# **VICKERY EXTENSION PROJECT**

## **ENVIRONMENTAL IMPACT STATEMENT**

## **PEER REVIEW LETTERS**

**KA Peer Review of HydroSimulations  
Groundwater Modelling Assessment of the  
Vickery Extension Project**

**Figure 3-2: FFA for the Namoi River at Gunnedah (gauge no. 419001) Fig 4.3 (WRM 2018)**

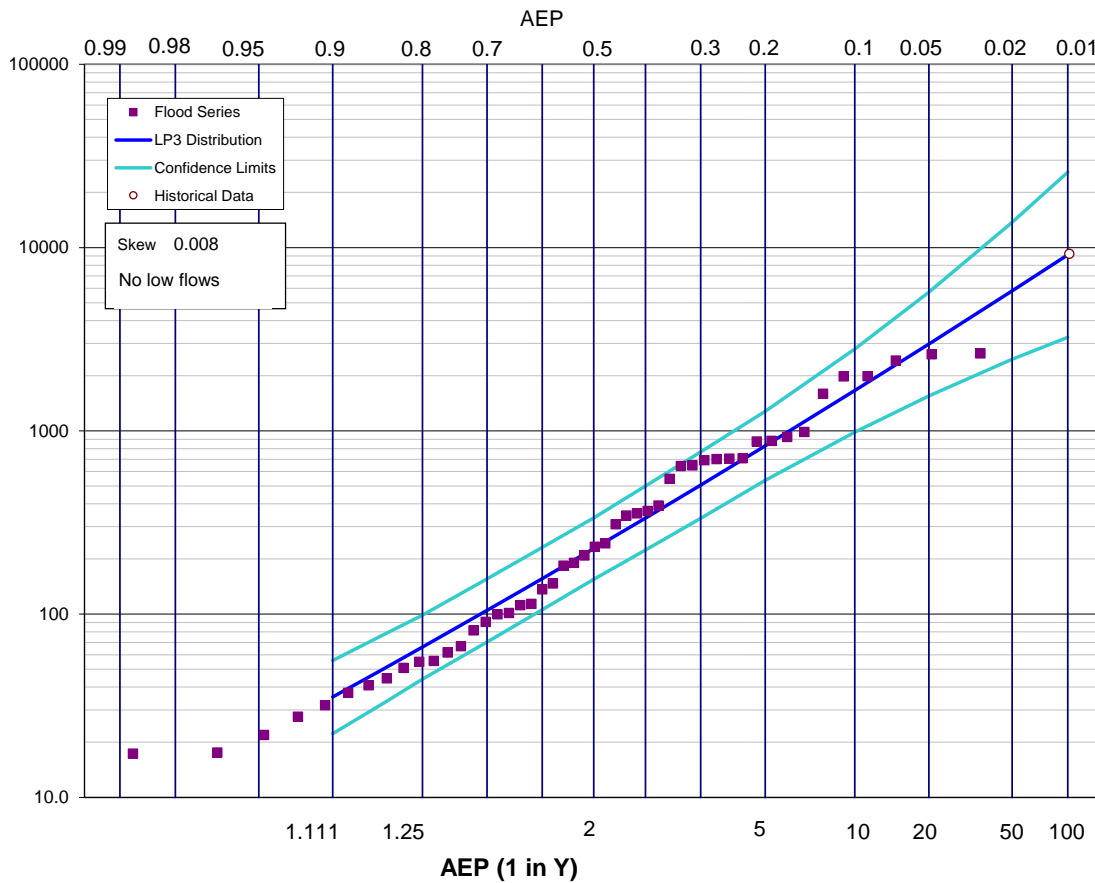
**Figure 3-2** shows the FFA for the Namoi River at the Gunnedah stream gauge as a LPIII distribution fitted to the annual series. The 95% and 5% confidence limits of the estimate are also shown. **Table 3-3** shows the WRM (2018) estimated peak discharges for the 20%, 5% and 1% AEP design flood events including the peak discharges for three historical events from the LPIII distribution. The results suggest that the 1955 flood had an AEP of about 1% and the 1998 event had an AEP of about 7%.

It should be noted that the “Flood Series” in **Figure 3-2** refers to 1968 to 2015 recorded stream data at the Namoi River Gunnedah gauge station. “Historical Data” refers to the derived peak discharge for the 1955 flood event. It is reported that the Gunnedah and Carroll Floodplain Management Study adopted by Gunnedah Shire Council (SMEC, 1999) concluded that the 1955 flood event had an AEP of between 1.4% and 1.0% and the Carroll to Boggabri Flood Study (SMEC, 2003) concluded that the 1955 flood event had an AEP of 1% at the Gunnedah stream

gauge. WRM reports that FFA results are consistent with previous studies and are suitable for this study, however, no results of the previous study were provided for comparison.

**Figure 3-3: BoM Automated FFA for the Namoi River at Gunnedah (gauge no. 419001)**

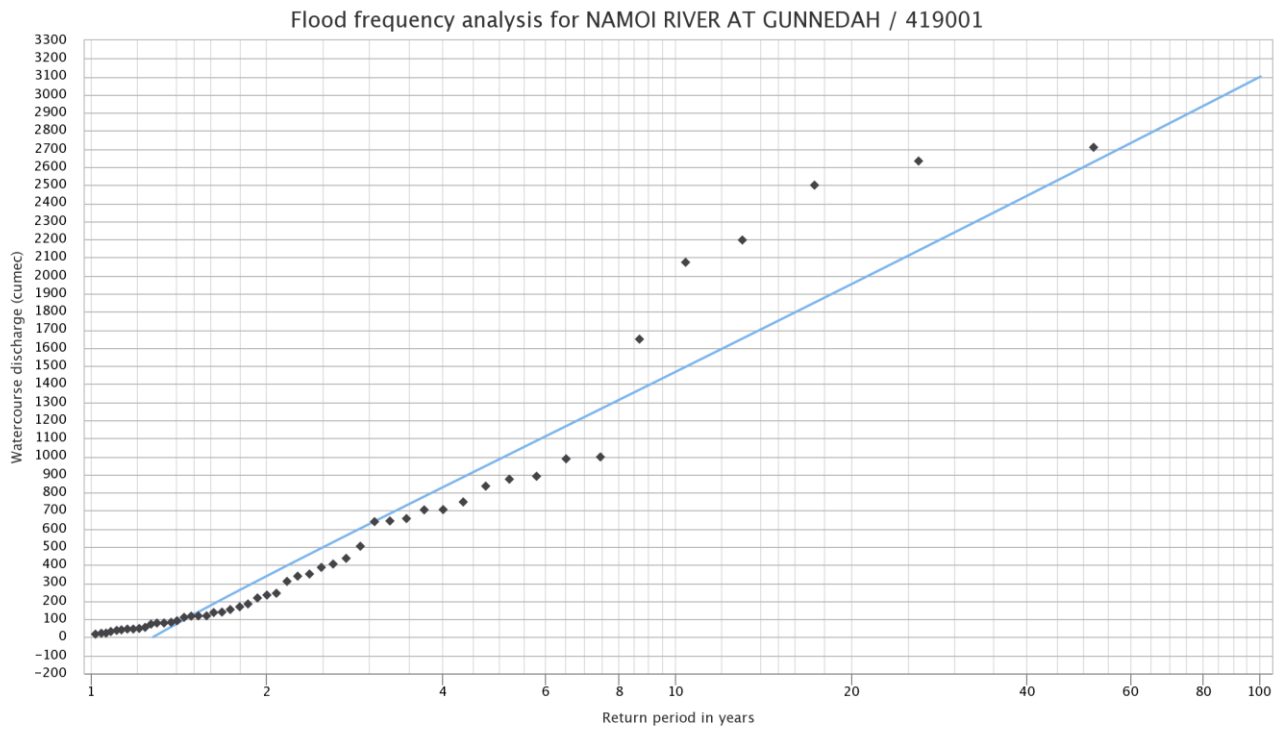
A desktop check of the design discharge for the Namoi was undertaken using the BoM water data website (<http://www.bom.gov.au/waterdata/>). An automated FFA for the Namoi River (Gunnedah) gauge is presented in Figure 3-2 and indicated a 1% AEP discharge of only 3100 m<sup>3</sup>/s. However, it is important to note that this only considers data from 1968 to 2018 so does not include the large 1955 event. Inclusion of the 1955 event significantly increases the estimates of rare flood discharges and results in the estimation of the 1% AEP as being 9141 m<sup>3</sup>/s.

**Figure 3-4: BoM Automated FFA for the Namoi River at Boggabri (gauge no. 419012)**

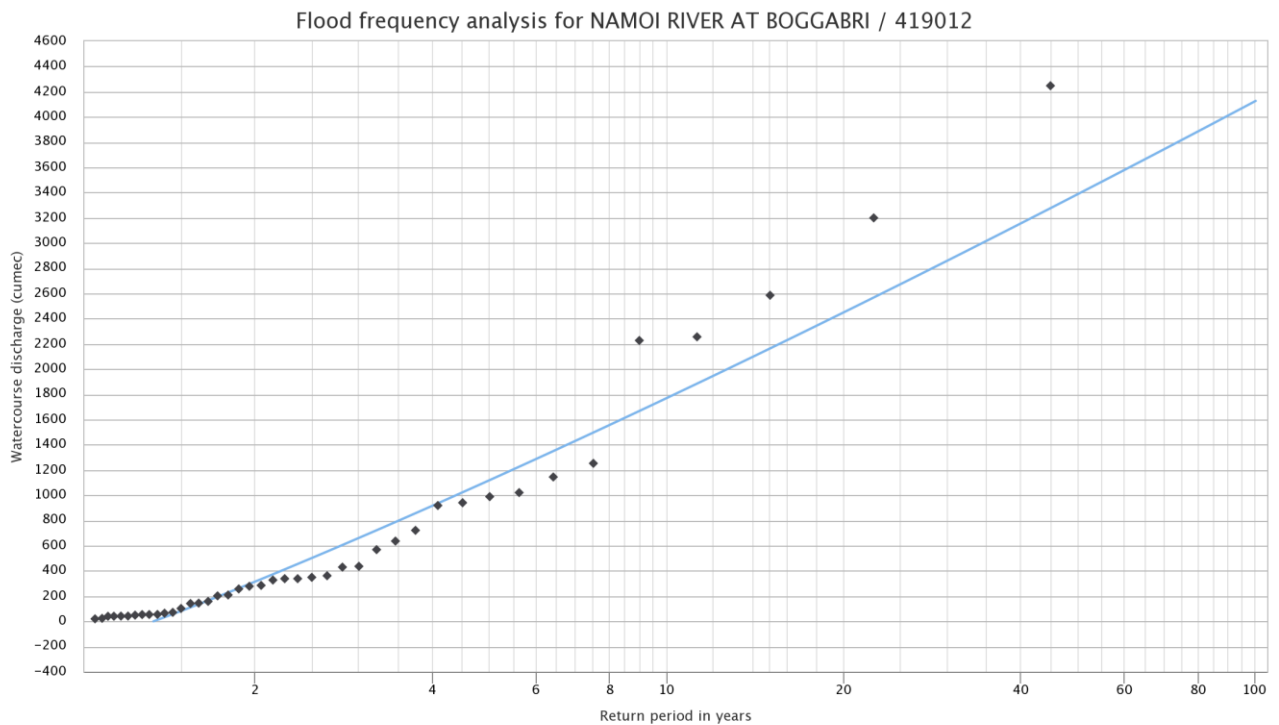
A check of the design flows at the Boggabri gauge (i.e. the gauge downstream of Gunnedah) using the BoM water data website is presented in **Figure 3-4** and indicated a 1% AEP discharge of 4150 m<sup>3</sup>/s. This seems low compared to design WRM (2018) discharge estimates from the Gunnedah gauge, especially as it includes the data from 1955 to 2018 and includes the peak flow from the February 1955 event (though the discharge from this event was only 4247 m<sup>3</sup>/s). The significantly lower discharge observed at Boggabri for the 1955 events either indicates an error with the rating curve or significant floodplain storage occurring between the two gauges. Given the very wide floodplain and low channel gradient, significant floodplain storage is considered likely.

Figure 3-5: XP-RAFTS model configuration for Namoi River Tributaries (Fig 4.4 WRM)

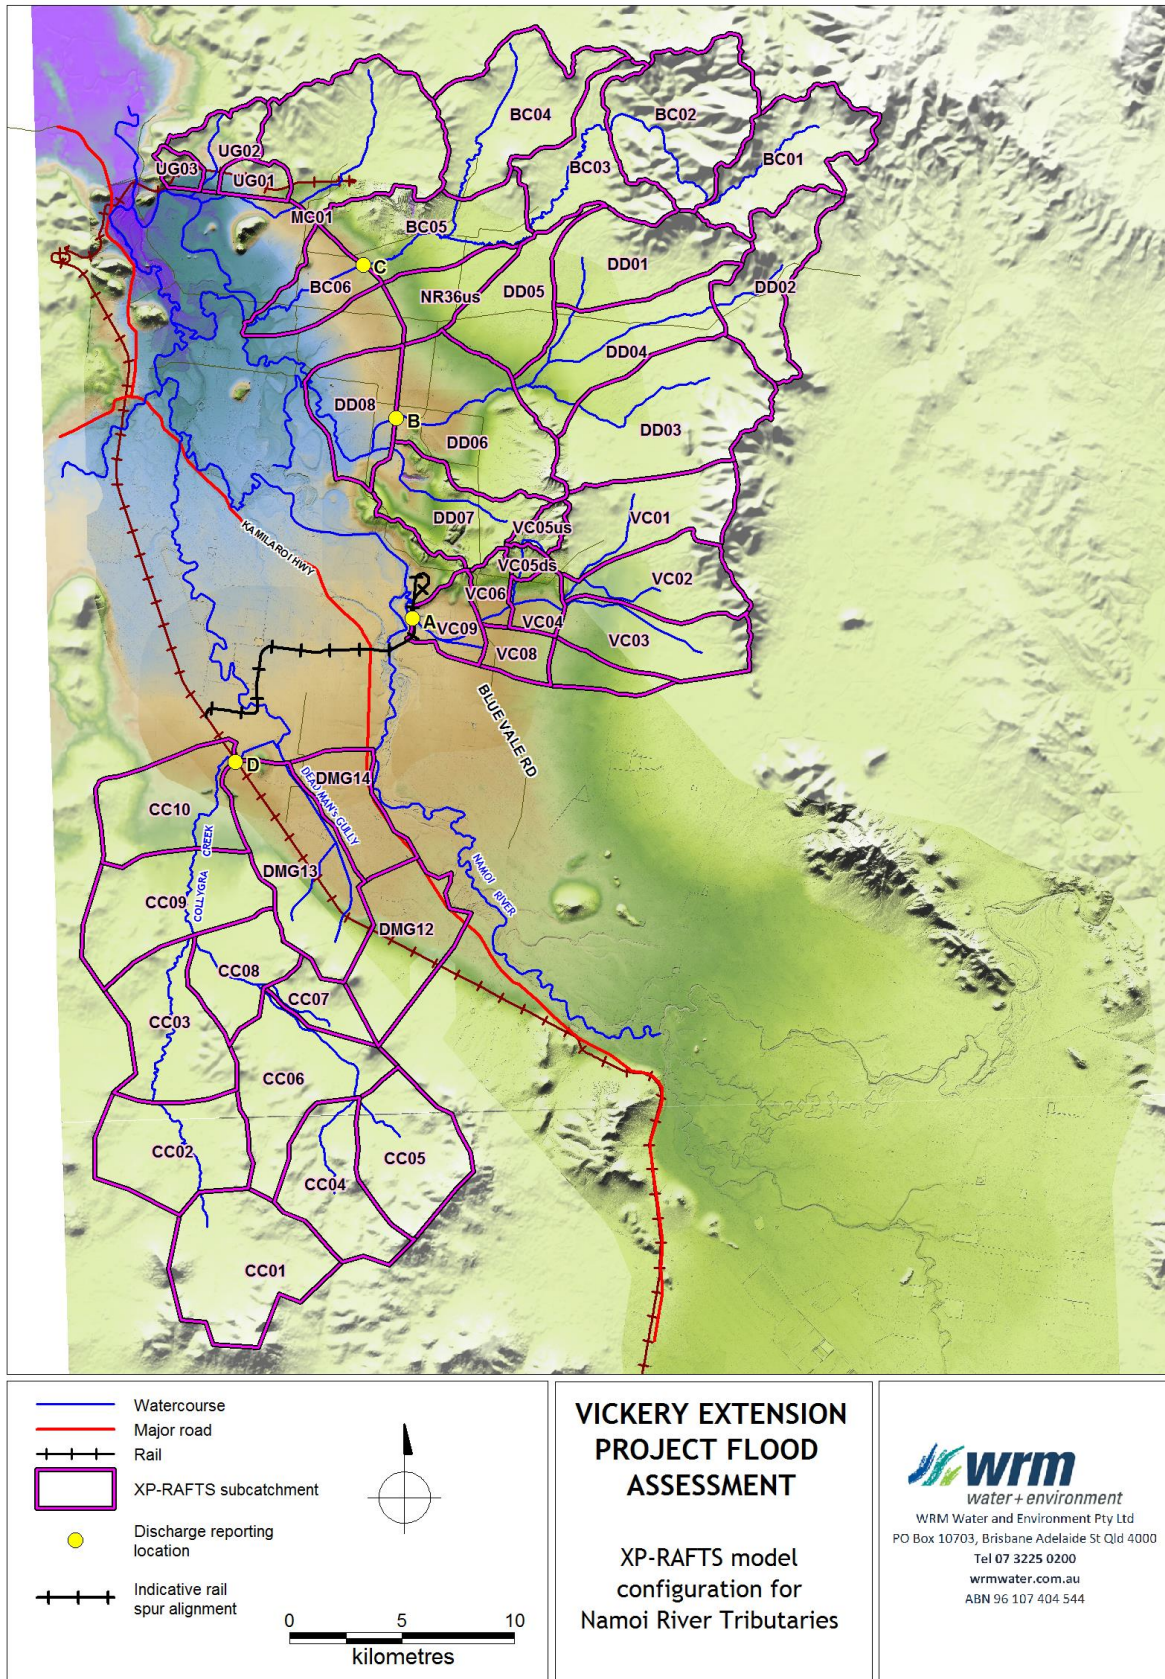
Review Element	Comment
Catchment Discretisation	Catchment discretisation of the sub-catchment used in the model is presented in Figure 3-5 (below) and summarised in Table 4.2 of (WRM, 2018). It appears to be appropriate.
Catchment Parametrisation	Area: Assumed to be from GIS and hence likely accurate (range 2.2 to 43.5 km <sup>2</sup> ) Slope: Assumed to be from GIS and hence likely accurate (range 0.2 to 2.2%) Roughness: Ranges between 0.06 and 0.08 which appears reasonable Routing: <i>Channel routing was modelled using the Muskingum method with a storage exponent 'X' of 0.25. The sub-catchment and routing link parameters were adjusted to obtain the best match between modelled discharges and those estimated using the</i>

**Figure 4-1: Namoi River TUFLOW model configuration (existing conditions)**

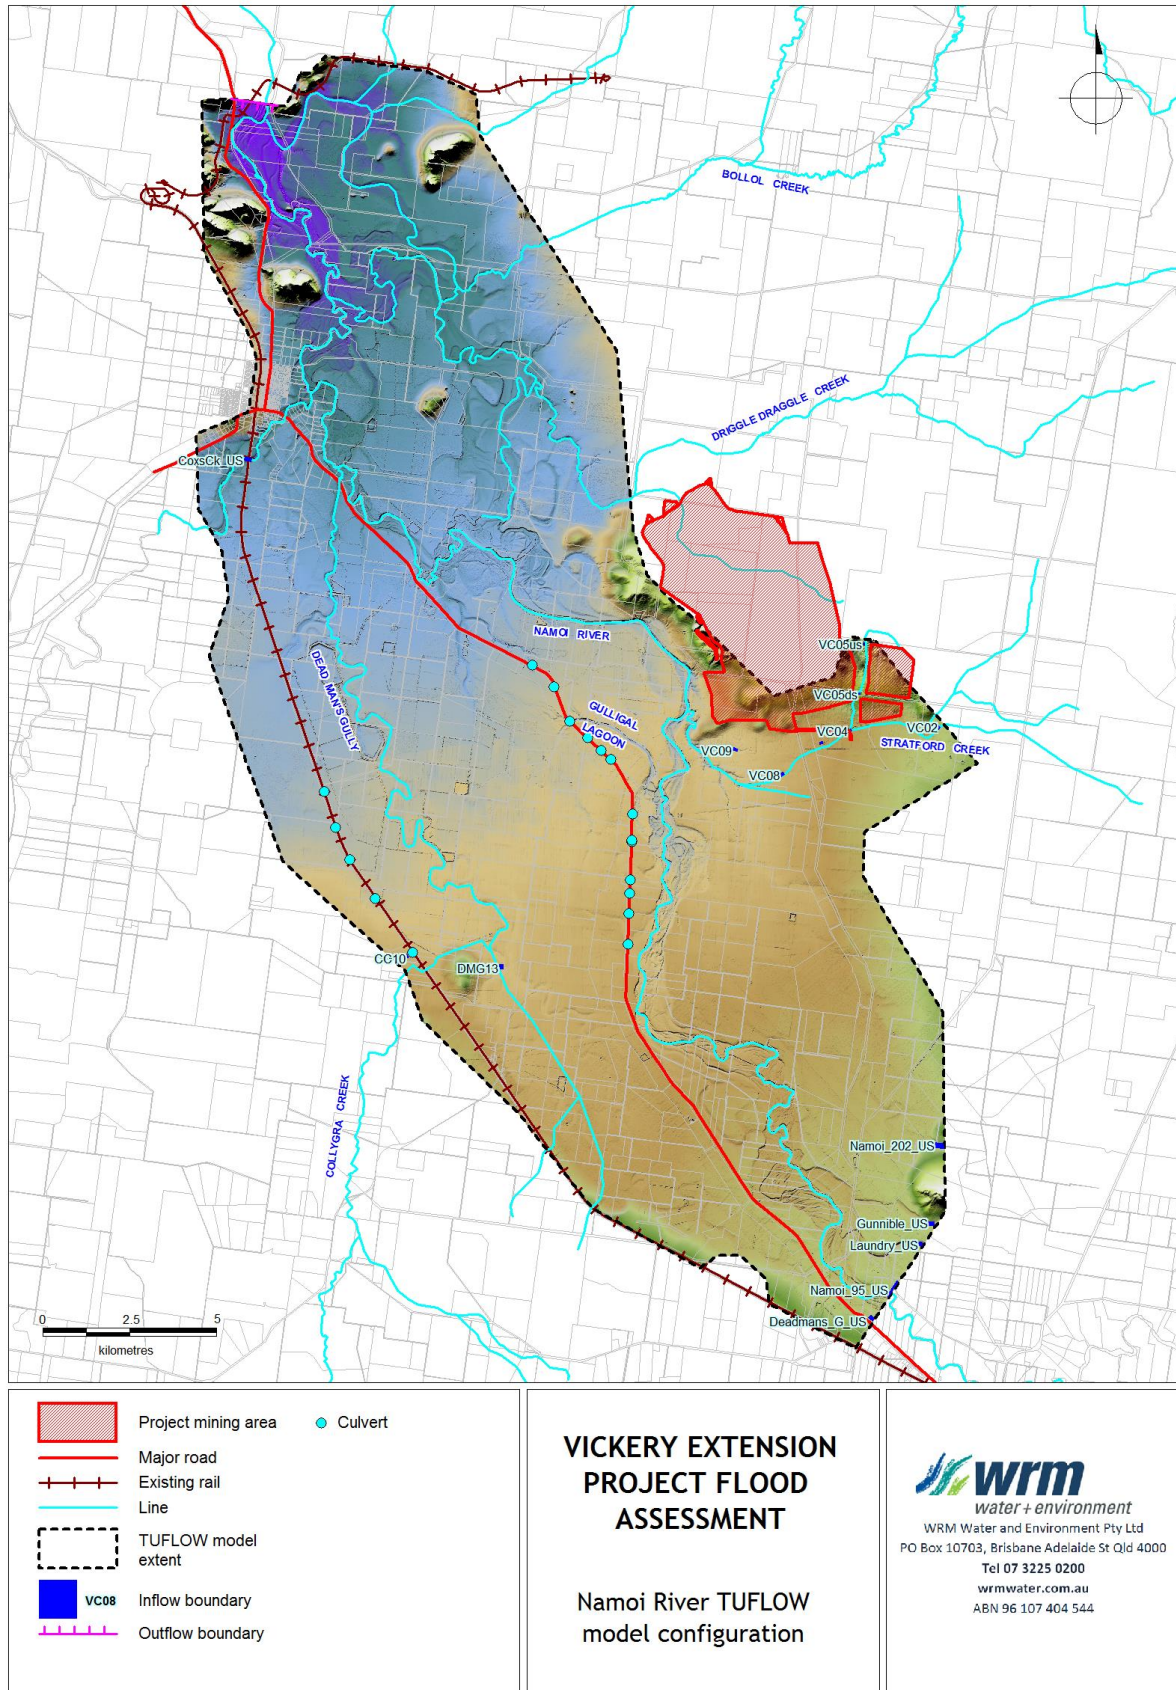
Review Element	Comment
Model Extents	The model extents are considered appropriate however, extending the model slightly (i.e 1-2km d/s of Rangari Rd) downstream would allow a check of observed discharge at the Boggabri Gauge to be made. Extending the model further upstream to the Gunnedah Gauge would also be beneficial for calibration and validation and to allow a check of the gauge rating to be made.
Model Resolution	A 15m grid resolution was adopted and is considered appropriate for the study area.
Inflow Boundary	Design inflows for the Namoi and local catchment were reviewed in Chapter 3 and appear appropriate. Hydrograph shape/volume is based on the 1984 event as provided in the SMEC (2003) Mike 11 model. Calibration and validation event inflows are based on SMEC (2013) and are assumed to be correct.
Downstream Boundary	A single normal depth outflow boundary was adopted for the Namoi River model. The outflow boundary of this model is located approximately 23 km downstream of the Approved Mine and as such would not impact on peak flood levels at the Project area. This is considered appropriate.
